**World Forum for Harmonization of Vehicle Regulations****Working Party on Passive Safety****Fifty-ninth session**

**Regulation No. 16 (Safety-belts)****Proposal for Supplement 8 to the 06 series of amendments to  
Regulation No. 16 (Safety-belts)****Submitted by the expert from the Netherlands\***

"Figure 1  
Specifications of the fixture

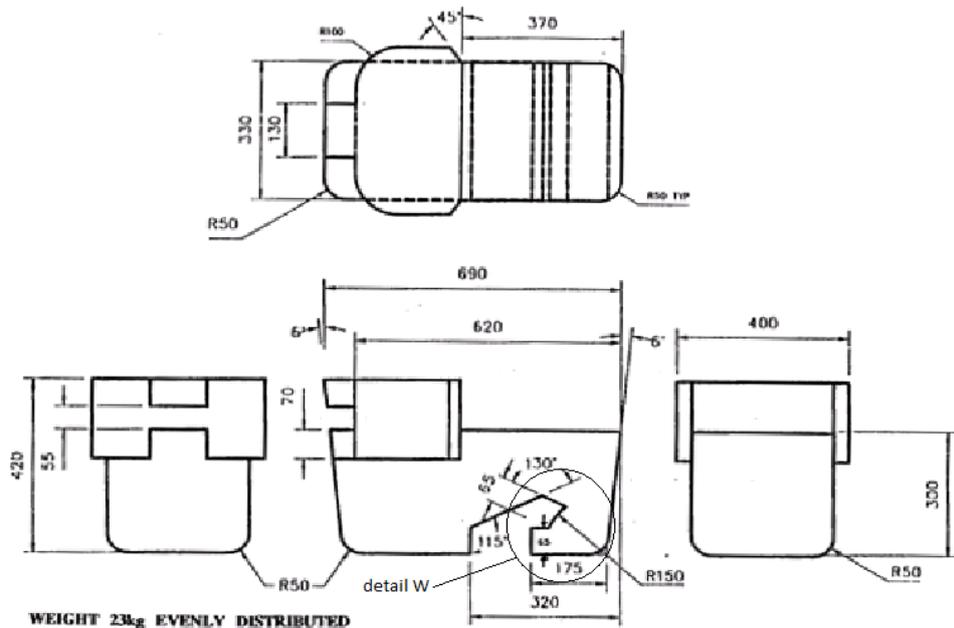
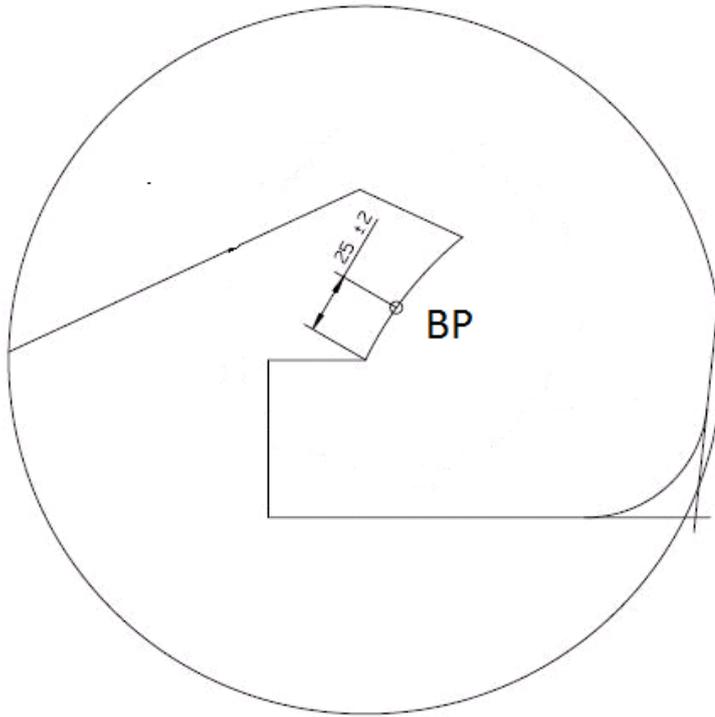
"3.2. The lap portion of the belt shall touch the fixture on both sides at the rear of the lap belt path (see Figure 3). **The seat belt webbing shall always cover the points BP on the left and right ends of the curved edge; the exact position of point BP on the curved edge is indicated in detail W of Figure 1.**

Figures 1 to 3, amend to read:

3. Annex 17, Appendix 1, paragraph 3.2.: So far the test requirements for the belt path are in paragraph 3.2. and Figures 2 and 3. Moreover, the current text could lead to misinterpretation. Accordingly, with the current proposal all test requirements are now concentrated in paragraph 3.2. and most notably what is meant of "shall contact" is clarified by adding a coverage point BP that is also defined in detail W.

Figure 3  
Check for compatibility  
(see paragraphs 2.6.1. and 3.2)

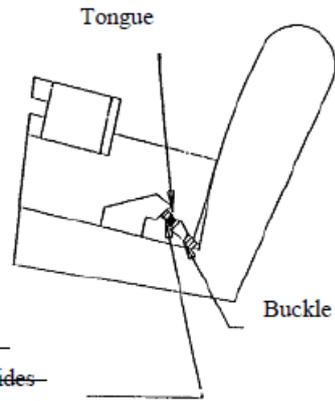
*Note:* The seat belt webbing shall contact the curved edge on both sides of the fixture
